LETTER FROM NAVY REQUESTING A TIME EXTENSION FOR SUBMISSION OF  
CORRECTIVE ACTION PLAN AND INTERIM MEASURES REPORT FOR SITE 11 NSB KINGS  
BAY GA  
3/20/1996  
NSB KINGS BAY

This letter summarizes our review of Interim Measure Phase I Activities: Evaluation and Recommendations Report Addendum, Site 11, Old Camden County Landfill, Naval Submarine Base, Kings Bay, Georgia. The version of the report we reviewed is the Preliminary Draft version, labelled 'Working Draft' on grey page banner, and dated February, 1996. It was prepared by ABB Environmental Services, Inc., for the Navy, SouthDiv, who asked the USGS to review it. Enclosed you will find the annotated manuscript we reviewed.

WATER LEVELS, APRIL, 1994

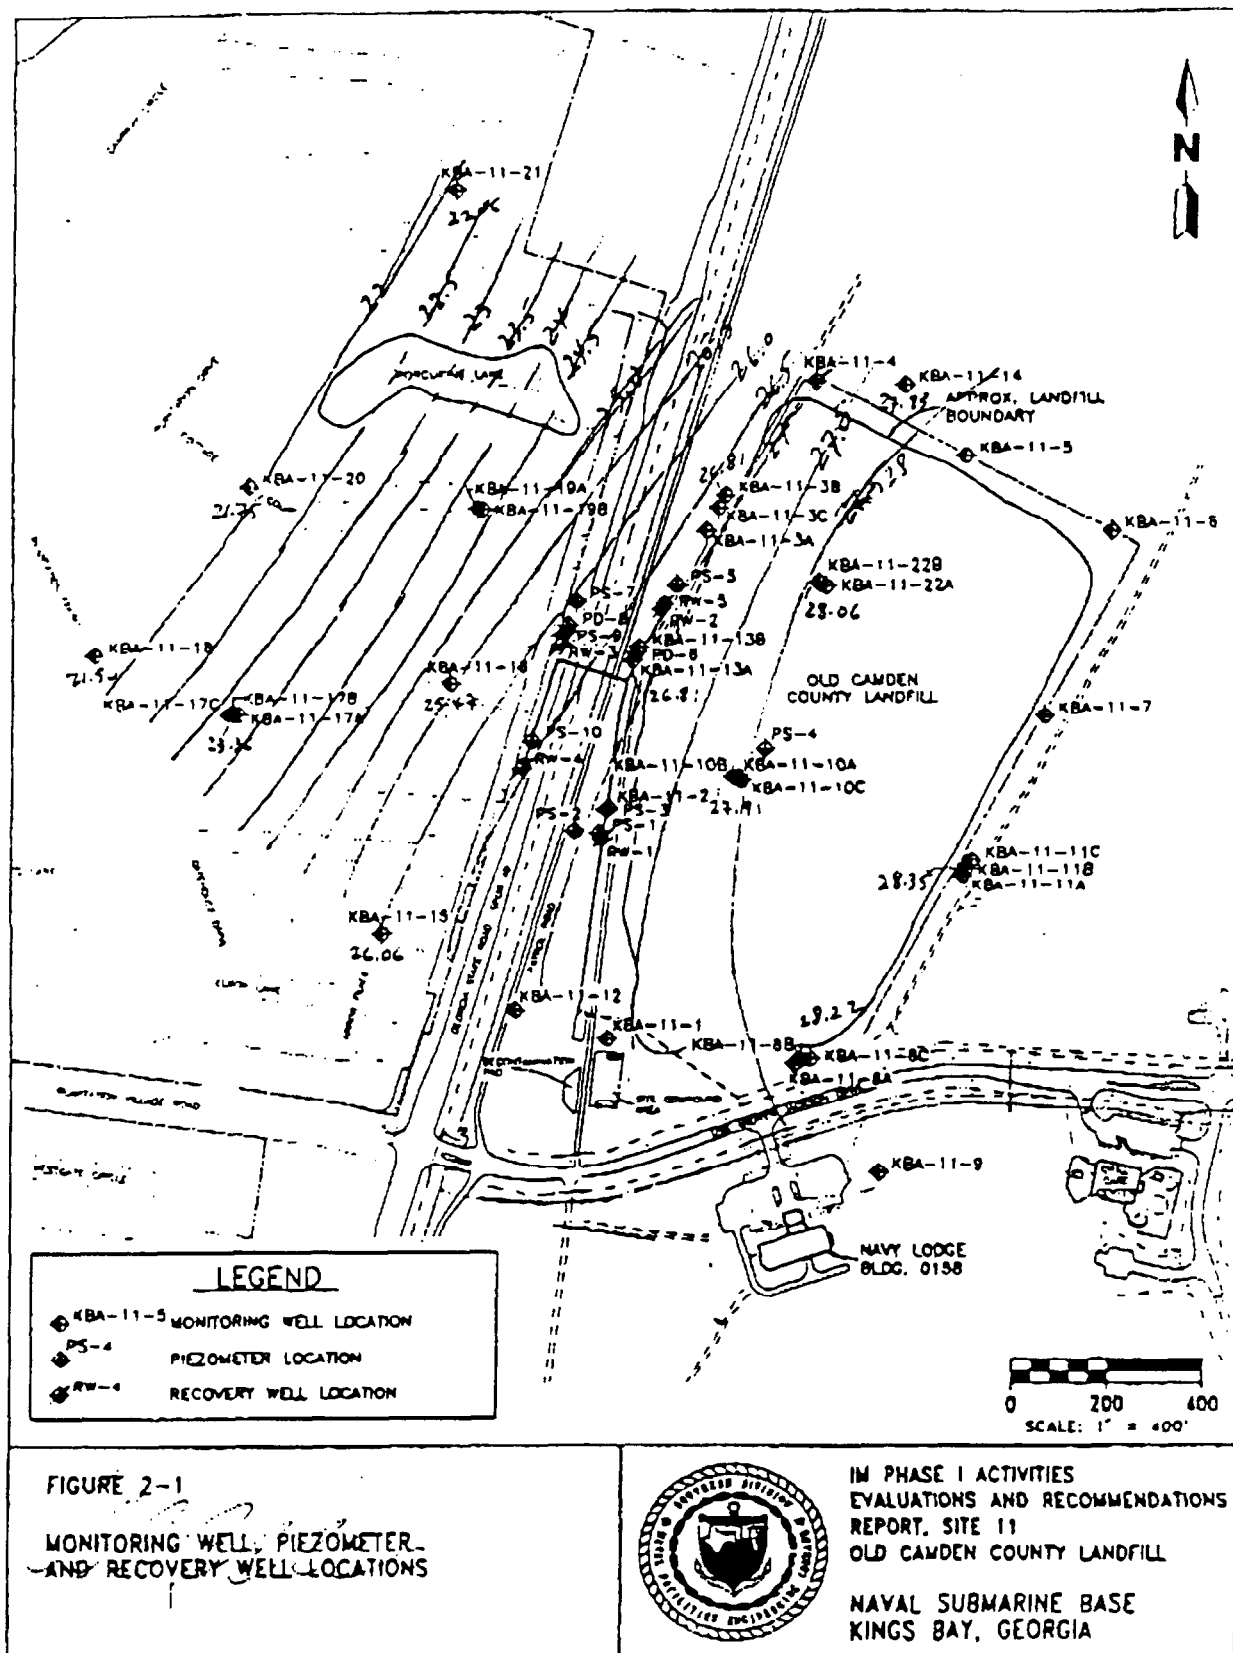
- p. 2-18. Plotting the location of every monitoring well on Figure 2-2 is unintentionally misleading, because it implies that water-level measurements for each well were used in the construction of this water-level surface. Since a small subset of these wells was used to generate the potentiometric surface shown, only the pertinent data should be plotted in this figure, not all the unused well symbols and IDs, which are a distraction. If it is necessary to indicate to the reader the locations of all the monitoring wells, it could be done in another

figure. Also, enclosed for consideration, is a different interpretation of this potentiometric surface based on the data in the Supplemental RFI Report.
